# Intel<sup>®</sup> StrongARM<sup>\*</sup> SA-1110 Development Board

Specification Update

*October 2000*

Order Number: [278325-004](#)

Figure 4-6. Interlaced Frame Buffer

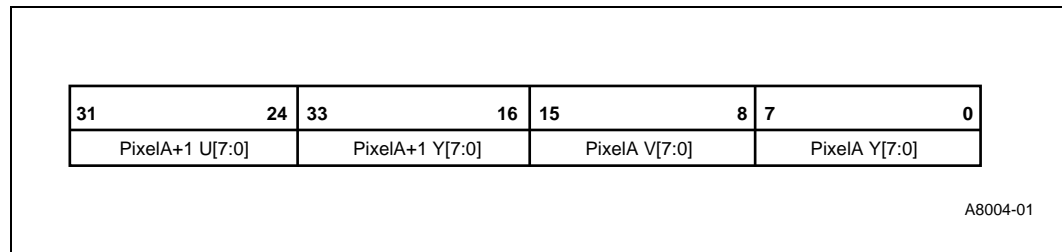
## 1. Added Video Output Design Section to Chapter 4

Added Video Output Design in Section 4.17. Section 4.17 now appears as follows in the *Intel® StrongARM® SA-1110 Evaluation Board User's Guide*:

### 4.17.4 Interlaced Display Buffer

The video image in the SA-1110 DRAM must be written in interlaced order and with regard to where the two fields are normally blanked. Although this complicates the rendering code, it is possible to design rendering routines that are just as efficient as normal line sequential rendering. The interlaced frame buffer image in SA-1110 DRAM contains YUV components in 4.2.2 format. Each 32-bit word in the DRAM frame buffer contains four 8-bit video components appearing as UYVY.

**Figure 2-3. Li-Ion Battery Location**

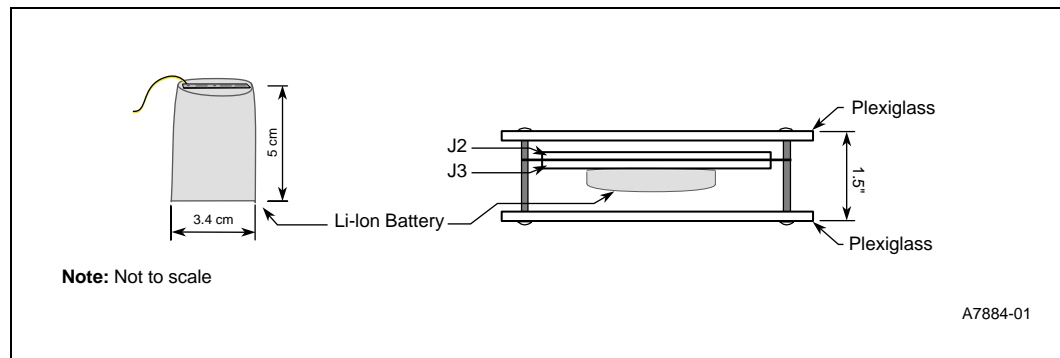
## 3. Connecting Power from an AC Adapter: Section 2.2.1

This section has been modified, renamed, renumbered and now appears as follows:

1. Verify that the Li-Ion battery is installed on the SA-1110 Development Board and that the battery harness is connected to J4 (see [Figure 2-3](#) for the location of the Li-Ion battery).

**Figure 2-6. Li-Ion Battery Location**

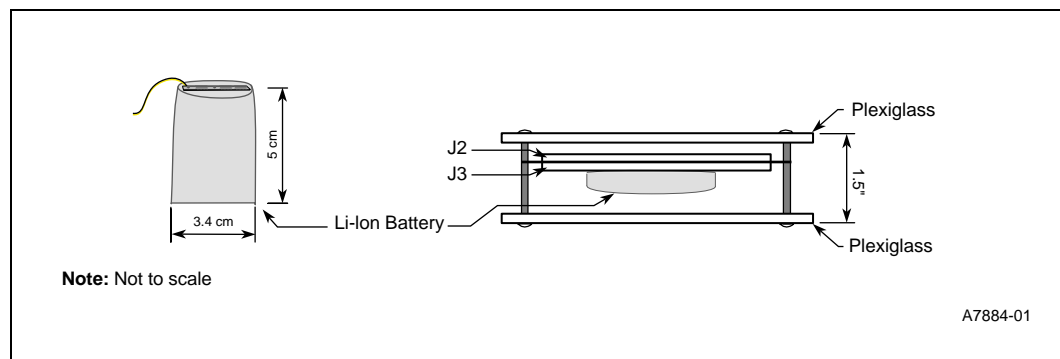
#### 4. Connecting Power from the Li-Ion Battery: Section 2.2.2

This section has been modified, renamed, renumbered and now appears as follows:

1. Disconnect the battery harness from J4 and remove the Li-Ion battery from the SA-1110 Development Board (see [Figure 2-6](#) for the location of the Li-Ion battery).

**Figure 4-8. Waking Circuit**

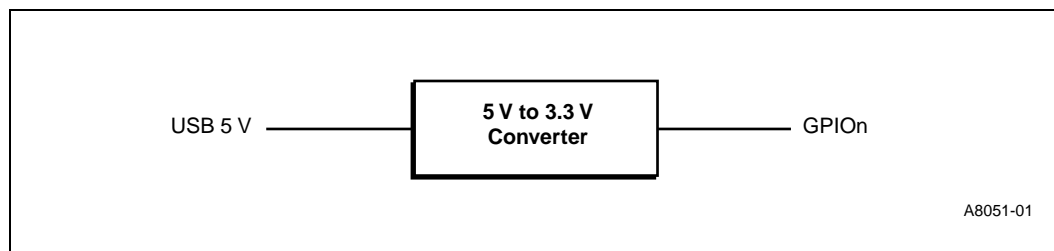
## 8. USB Client Port: Section 4.18

This section has been updated as follows:

To allow the USB to wake up a sleeping SA-1110 Development Board when it is plugged into a USB host port, the following circuit is required:

To prevent the SA-1110 Development Board from drawing power from the USB host, remove D6.
